FORMAL OBJECTION TO SSD-88702457 AND CONCURRENT PLANNING PROPOSAL St Francis Xavier, Lavender Bay

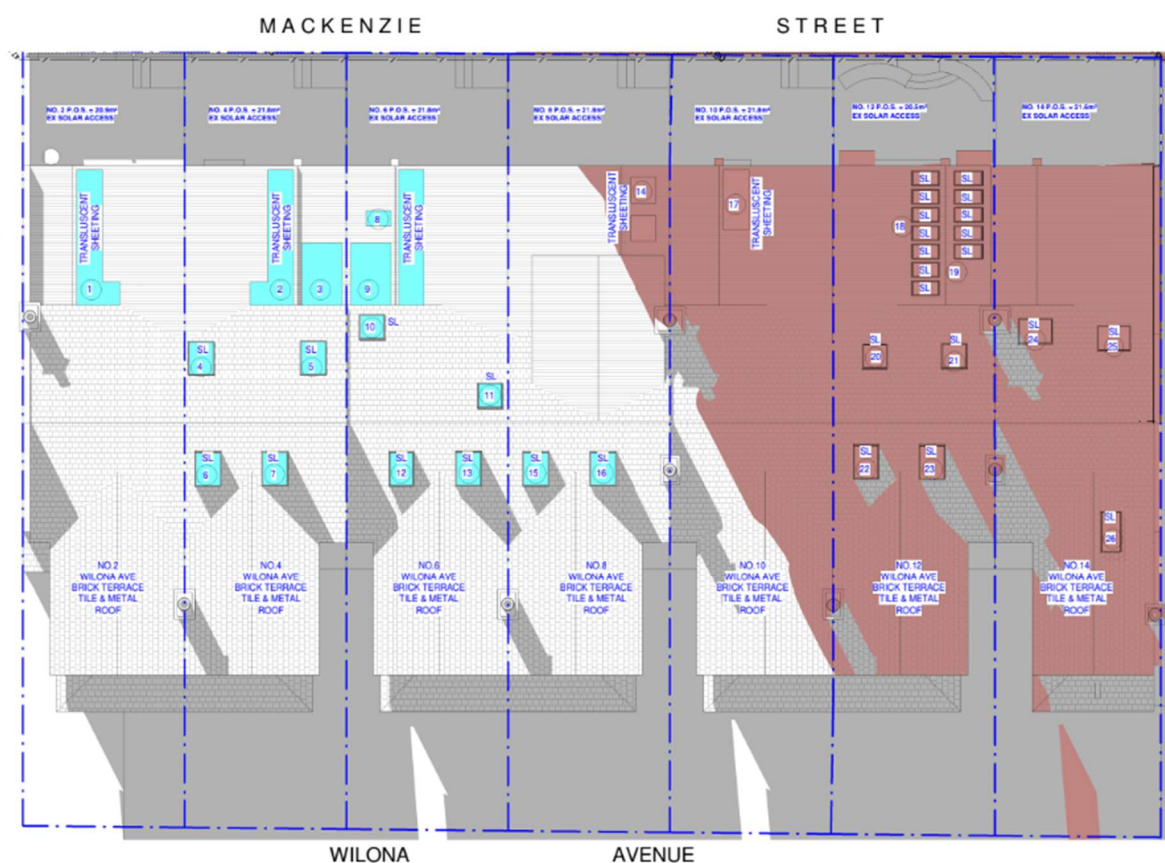
The EIS's treatment of solar access, visual impact and privacy is of particular concern. The solar assessment does not accurately represent the existing solar conditions or site conditions on Wilona Avenue or our lived experienced within our home which is bathed in natural northern sun throughout the day in Winter solstice. It appears to establish an existing condition in which my dwelling is effectively treated as receiving no sunlight and then characterises the incremental impact of the proposal as minimal. Please refer below solar analysis submitted by the Residents Opposing Lavender Bay Overdevelopment, showing assessment of my property at 1pm on Winter Solstice:

Figure 1a (above) and Figure 1b (below). Solar analysis submitted to the Department formally by the Residents Opposing Lavender Bay Overdevelopment, showing assessment of my property at 1pm on Winter Solstice Avenue. My property is bathed in northern sunlight. Note, two windows in my dwelling – a skylight and rear habitable room - are omitted in this diagram.

Therefore, the assessment in this EIS is not an acceptable baseline for assessing the impact on an immediately adjoining dwelling and is completely inaccurate. If the existing condition is incorrectly represented, the resulting assessment of incremental impact is compromised, and the Department cannot accept the impact as minor or nil.

Importantly, the solar assessment should clearly establish the sunlight currently experienced at Wilona Avenue and the actual hours of sunlight that would be lost resulting from this proposal, with all necessary steps taken to modify the design to minimise the impact.
